**CITY OF SAINT PAUL
HERITAGE PRESERVATION COMMISSION STAFF REPORT**

FILE NAME: 235 Mackubin Street
DATE OF APPLICATION: August 30, 2018
APPLICANT: John J. Moroney
OWNERS: same
DESIGNER: Britt Willis
DATE OF HEARING: September 20, 2018
HPC SITE/DISTRICT: Historic Hill Heritage Preservation District (1980, 85, 88, 91)
CATEGORY: New Construction
NRHP: Historic Hill District (1976)
SRHP: Historic Hill District (1974)
PERIOD OF SIGNIFICANCE: 1858-1938
CLASSIFICATION: Building Permit
ZONING: RT2 WARD: 1 PLANNING DISTRICT: 8
STAFF INVESTIGATION AND REPORT: Christine Boulware
DATE: September 17, 2018

B. PROPOSED CHANGES:

FRONT ELEVATION
SCALE: 1/4" = 1'-0"

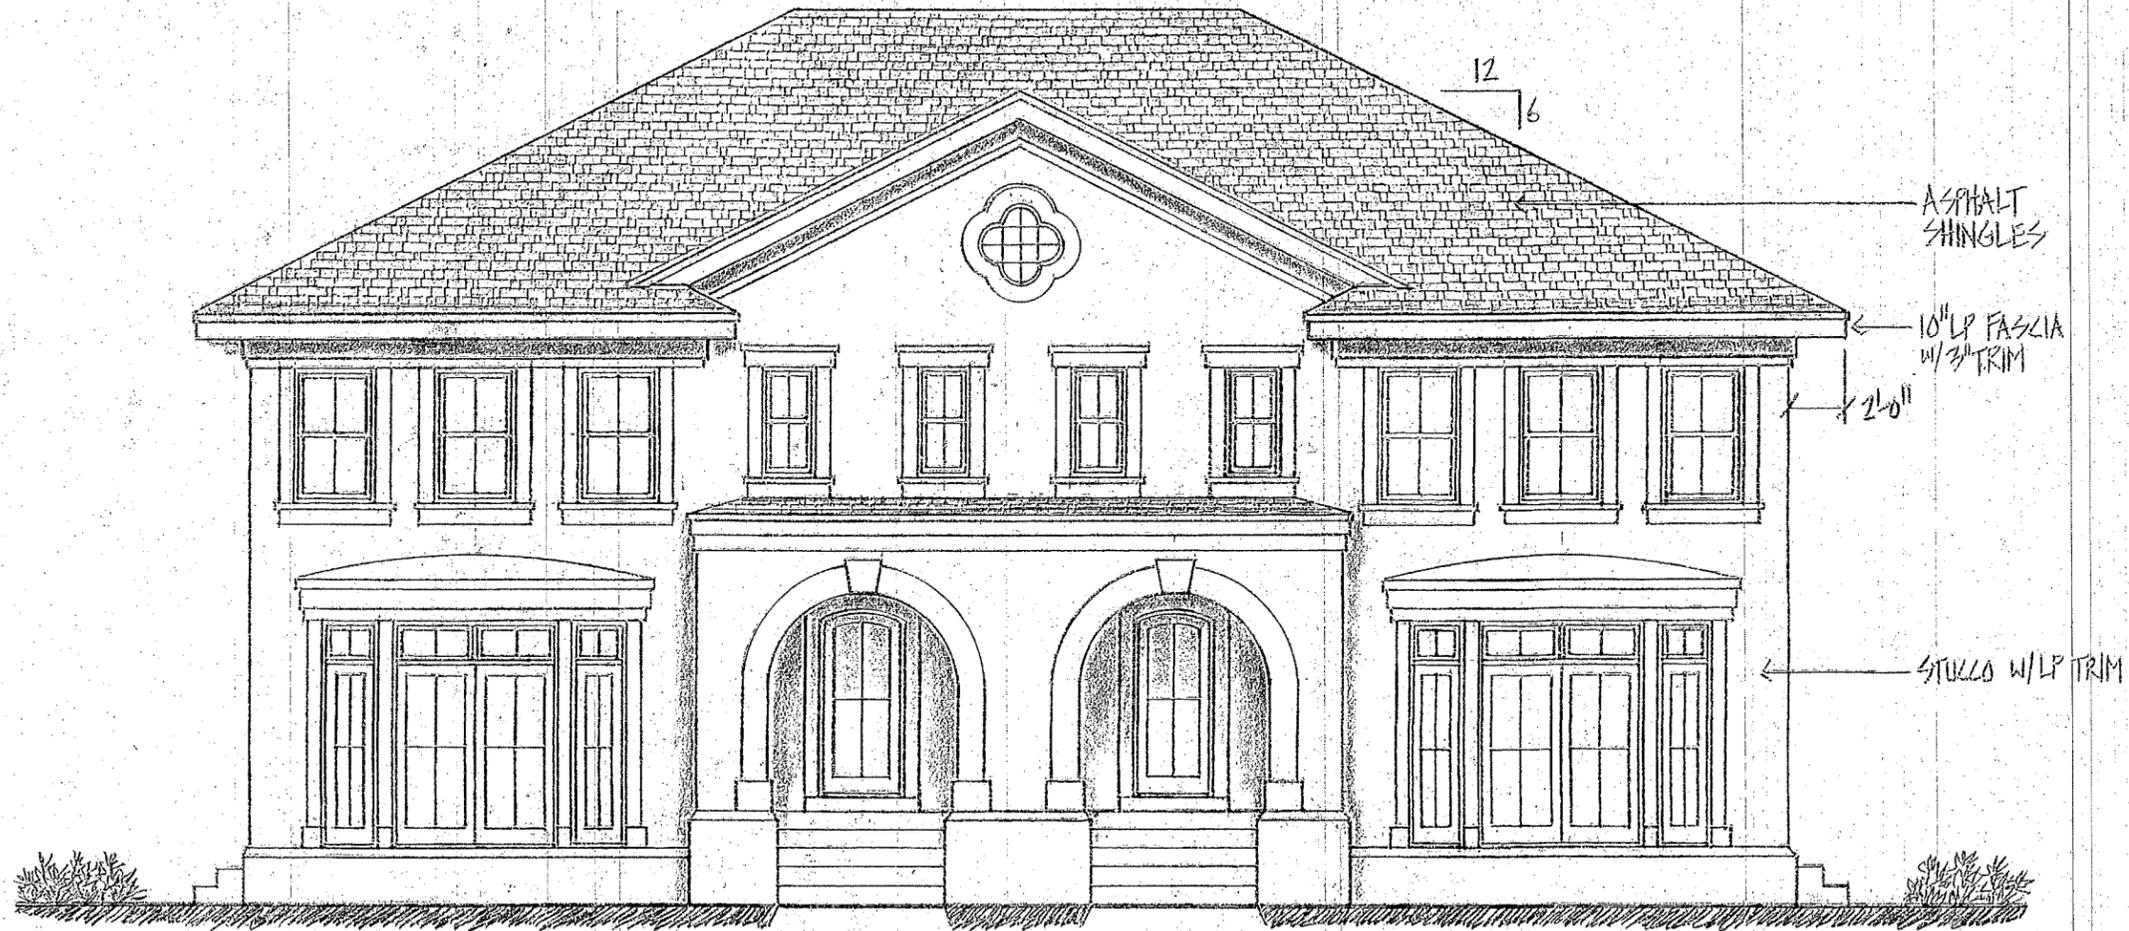
<p>Sec. 74.65 (b) Massing and Height:</p> <p><i>New construction should conform to</i></p>	Yes	<p>4. The proposed construction appears to relate to the massing, volume,</p>

<p><i>the massing, volume, height and scale of existing adjacent structures. Typical residential structures in the Historic Hill District are twenty-five (25) to forty (40) feet high. The height of new construction should be no lower than the average height of all buildings on both block faces; measurements should be made from street level to the highest point of the roofs. (This guideline does not supersede the city's zoning code height limitations.)</i></p>		<p>height and scale of the existing adjacent structures. Because its layout is side-by-side and not up-down, the broadside of the building faces the street; this differentiates it from the historic Spanish Colonial Revivals and is consistent with the footprint of the apartment building to the south.</p>
<p>Sec. 74.65 (c) Rhythm and Directional Emphasis: <i>The existence of uniform narrow lots in the Historic Hill District naturally sets up a strong rhythm of buildings to open space. Historically any structure built on more than one (1) lot used vertical facade elements to maintain and vary the overall rhythm of the street rather than interrupting the rhythm with a long monotonous facade. The directional expression of new construction should relate to that of existing adjacent structures.</i></p>	<p>Yes</p>	<p>5. The historic lot is square-shaped and given the siting of the other buildings on the corner, there is not a consistent rhythm along this portion of the block. The directional emphasis is complimentary to the historic adjacent structures, but also differentiates the new construction from the historic Spanish, Colonial Revival duplexes.</p>

<p>Sec. 74.65 (d)(1) Material and Details: <i>Variety in the use of architectural materials and details adds to the intimacy and visual delight of the district. But there is also an overall thread of continuity provided by the range of materials commonly used by turn-of-the-century builders and by the way these materials were used. This thread of continuity is threatened by the introduction of new industrial materials and the aggressive exposure of earlier materials such as concrete block, metal framing and glass. The purpose of this section is to encourage the proper use of appropriate materials and details.</i></p>		
<p>Sec. 74.65 (d)(2) Material and Details: <i>The materials and details of new construction should relate to the materials and details of existing nearby buildings.</i></p>	<p>Yes</p>	<p>6. The applicant proposes cladding the residence in stucco, which relates to the historic, adjacent buildings. While the adjacent buildings have wood trim and casings, the applicant proposes these features be stucco with a profile</p>

and different color, while not consistent with the adjacent buildings, the stucco trim detail can help to differentiate the new construction.
<p>Sec. 74.65 (d)(3) Material and Details:</p> <p><i>Preferred roof materials are cedar shingles, slate and tile; asphalt shingles which match the approximate color and texture of the preferred materials are acceptable substitutes. Diagonal and vertical siding are generally unacceptable. Imitative materials such as asphalt siding, wood-textured metal or vinyl siding, artificial stone, and artificial brick veneer should not be used. Smooth four-inch lap vinyl, metal or hardboard siding, when well installed and carefully detailed, may be acceptable in some cases. Materials, including their colors, will be reviewed to determine their appropriate use in relation to the overall design of the structure as well as to surrounding structures.</i></p>	Yes	7. The applicant proposes to install slate-colored, asphalt shingles on the roof. The stucco is proposed to be a warm-gray color with a smooth texture. The stucco trim details will be a complementary color to the main stucco color.

1. All new glass shall be two-way and have no reflective, tinted, or mirrored qualities.
2. Vents, utilities, or other mechanical protrusions shall not be installed on the primary elevation and if placed on the roof top shall be low and located on non-primary roof planes as much as possible. Vents, louvers, etc... shall be painted to match the surrounding material and shall be low profile.

3. All final materials, colors and details shall be submitted to the HPC and/or staff for final review and approval, including stucco specifications, handrail and guardrail details, hardscaping, landscaping (fence), and window and door brands, styles, and finishes, and screen/storm windows and doors.

UNIT-A 994H 1ST FLOOR PLAN 994H UNIT-B
SCALE 1/4" = 1'-0"

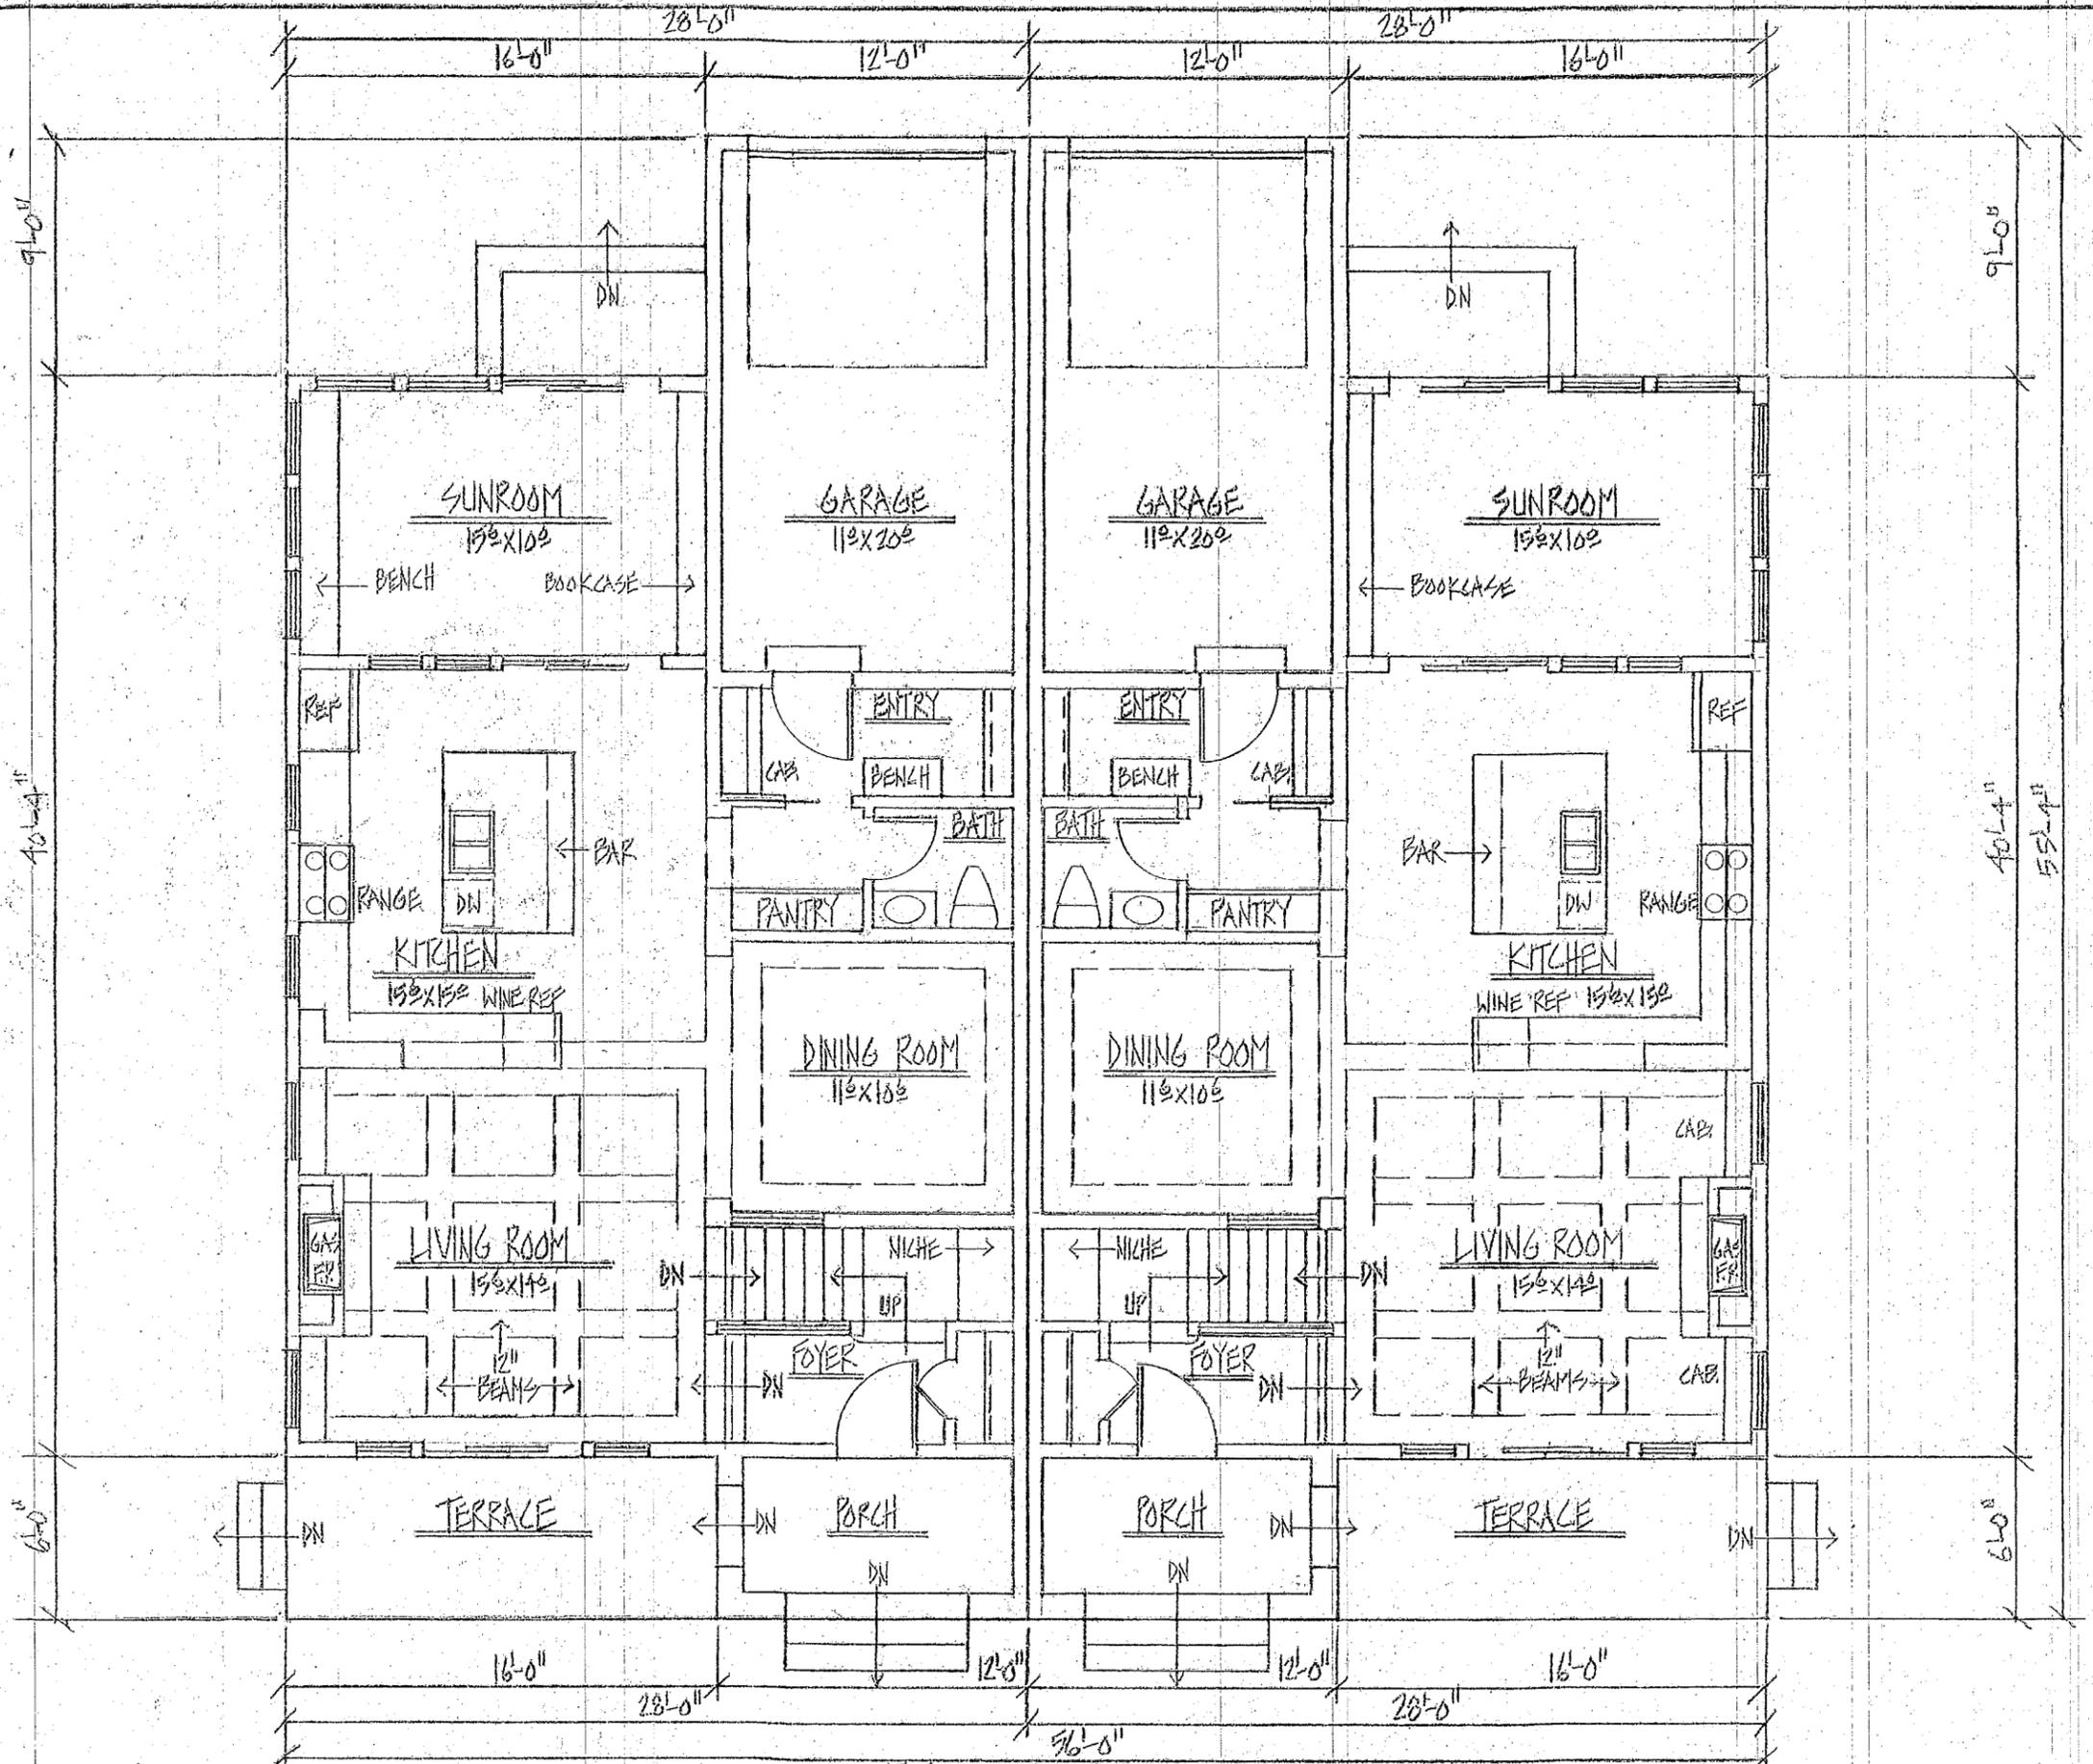
<p>Sec. 74.65 (e)(1)(c) Building Elements - Roofs:</p> <p><i>Roof hardware such as skylights, vents and metal pipe chimneys should not be placed on the front roof plane.</i></p>	<p>Not enough information</p>	<p>10. Skylights were not proposed. Venting and other mechanical locations are not shown on the plans and will require review and approval.</p>
<p>Sec. 74.65 (e)(2)(a) Building Elements - Windows and doors:</p> <p><i>The proportion, size, rhythm and detailing of windows and doors in new construction should be compatible with that of existing adjacent buildings. Most windows on the Hill have a vertical orientation, with a proportion of between 2:1 and 3:1 (height to width) common. Individual windows can sometimes be square or horizontal if the rest of building conveys the appropriate directional emphasis. Facade openings of the same general size as those in adjacent buildings are encouraged.</i></p>	<p>Yes</p>	<p>11. The window and door proportions, sizes, rhythm and details illustrated on the plans are compatible with adjacent buildings. Some are individual openings and others are grouped. All have a vertical orientation.</p>

<p>Sec. 74.65 (e)(2)(b) Building Elements - Windows and doors:</p> <p><i>Wooden double-hung windows are traditional in the Historic Hill District and should be the first choice when selecting new windows. Paired casement windows, although not historically common, will often prove acceptable because of their vertical</i></p>	<p>Yes</p>	<p>12. The applicant has indicated wanting to use Marvin aluminum-clad windows with a dark exterior finish. The double-hung, casement, piano-style, and transom windows all have precedent in the historic district. Details about the sash and muntin profiles were not provided, but will need to be reviewed.</p>
